U. S. NUCLEAR REGULATORY COMMISSION
OFFICE OF NUCLEAR REACTOR REGULATION

Report No.: 50-302/87-22

Facility Name: Crystal River Nuclear Generating Plant, Unit 3

CRYSTAL RIVER NUCLEAR GENERATING PLANT
OPERATIONAL SAFETY TEAM INSPECTION
INSPECTION REPORT 50-302/87-22

Figure 1 RAW WATER AND AUXILIARY COOLING WATER SYSTEMS

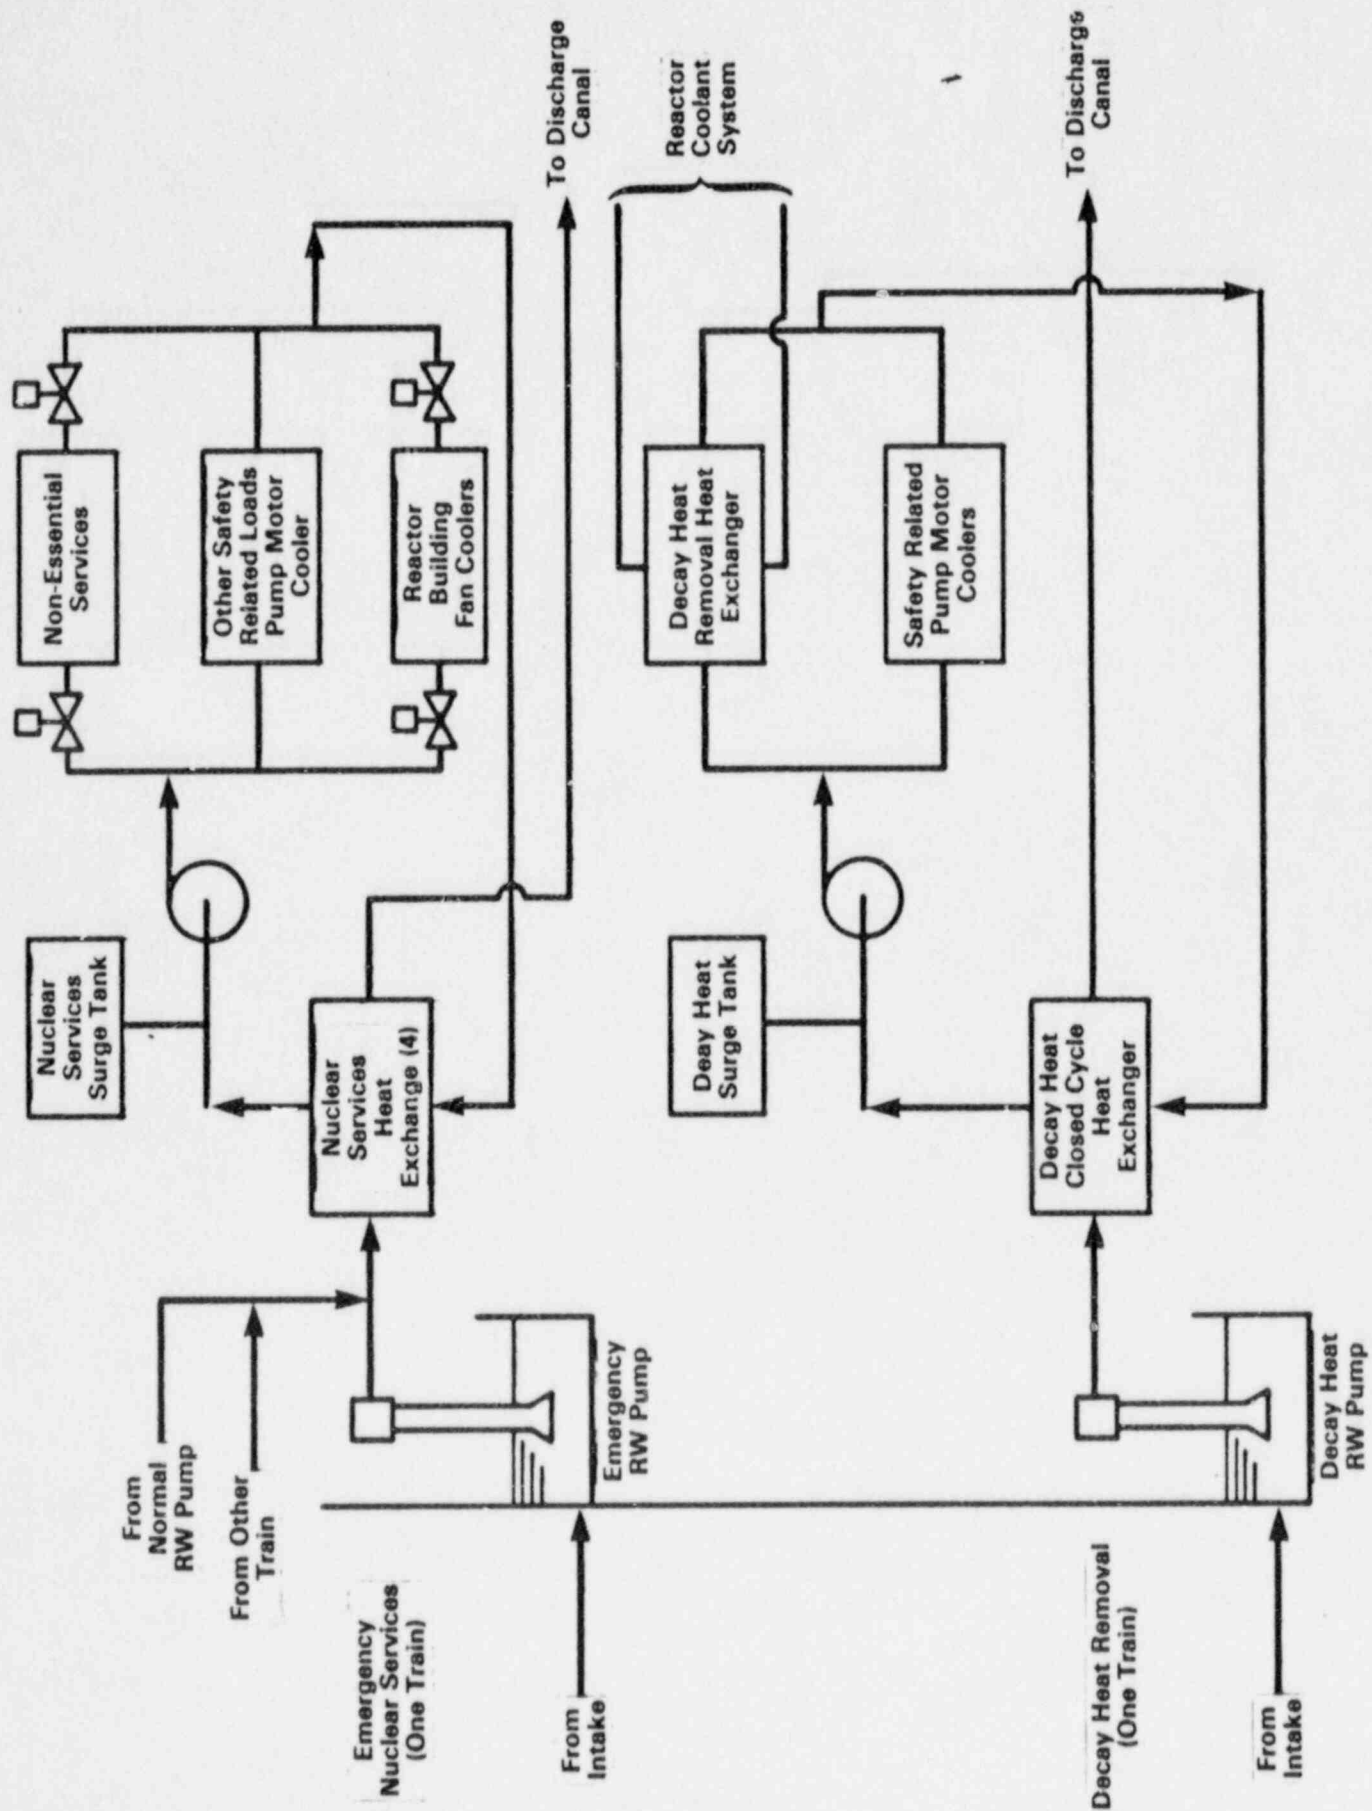
The decay heat closed cycle heat exchangers are cooled by the raw water system and supply cooling water to the decay heat removal heat exchangers and other safety-related equipment during a normal plant cooldown and during a postulated loss-of-coolant accident (LOCA). One decay heat removal heat exchanger cooled by one decay heat closed cycle heat exchanger constitutes a decay heat

removal train (Figure 1). During a normal plant cooldown, both decay heat removal trains are used to cool the plant to 140°F within 14 hours. However, in the event of a LOCA, only one of the redundant decay heat removal trains is required to accommodate the high accident heat loads during reactor building sump recirculation.
